The Commission has issued the enclosed Amendment No. 19 to Facility Operating License No. DPR-75 for the Salem Nuclear Generating Station, Unit No. 2. This amendment consists of changes to the Technical Specifications in response to your request dated January 31, 1983.

SALEM NUCLEAR GENERATING STATION, UNIT NO. 2

Amendment No. 19
License No. DPR-75

SAFETY EVALUATION BY THE OFFICE OF NUCLEAR REACTOR REGULATION
RELATED TO AMENDMENT NO. 19 TO FACILITY OPERATING LICENSE NO. DPR-75

Figure 3.1-1

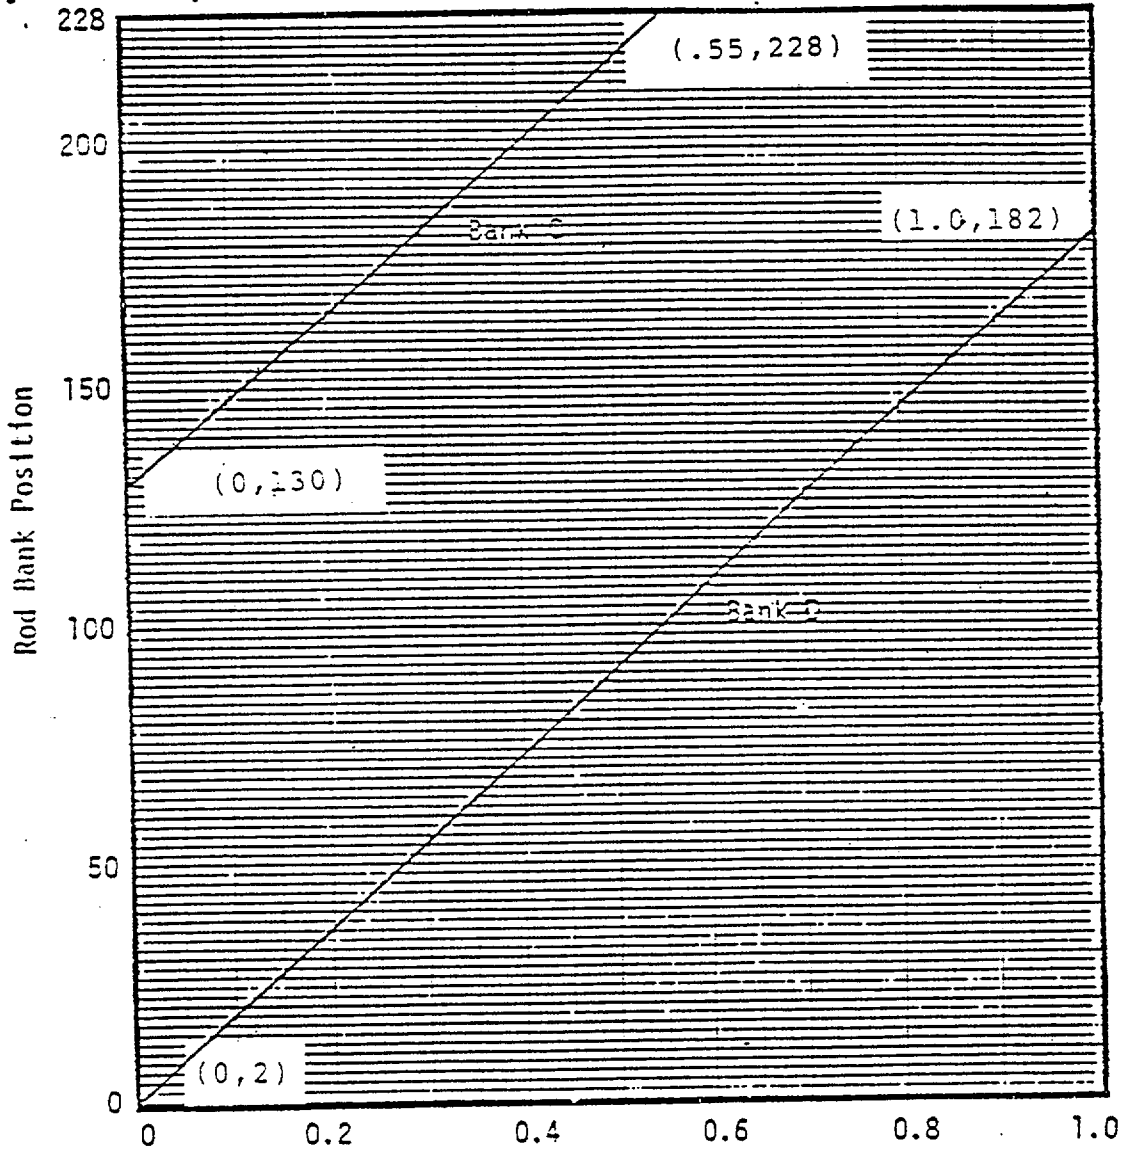
In a letter dated January 31, 1983, Public Service Electric and Gas Company submitted the results of a Reload Safety Evaluation (RSE) and a request for amendment to the Salem Unit 2 Technical Specifications. The Cycle 2 RSE was performed by Westinghouse using the methodology described in WCAP 9272. The evaluation showed the need for changes to the F_{xy} and rod insertion limit Technical Specifications.

A change to the Technical Specifications on F_{xy} was requested to remove the cycle dependent values of F_{xy} as a function of core height and provide these F_{xy} values by means of a Peaking Factor Limit Report. It is anticipated that F_{xy} will change from cycle to cycle and this change would eliminate the necessity of making a Technical Specification change for each reload. A similar change has been approved on other plants. A Radial Peaking Factor Limit Report was submitted with the January 31, 1983 letter for Cycle 2. We find this change acceptable. The rod insertion limit Technical Specification is also acceptable.

Based on our review we find that the proposed Technical Specification changes to the F_{xy} and rod insertion limit are acceptable.
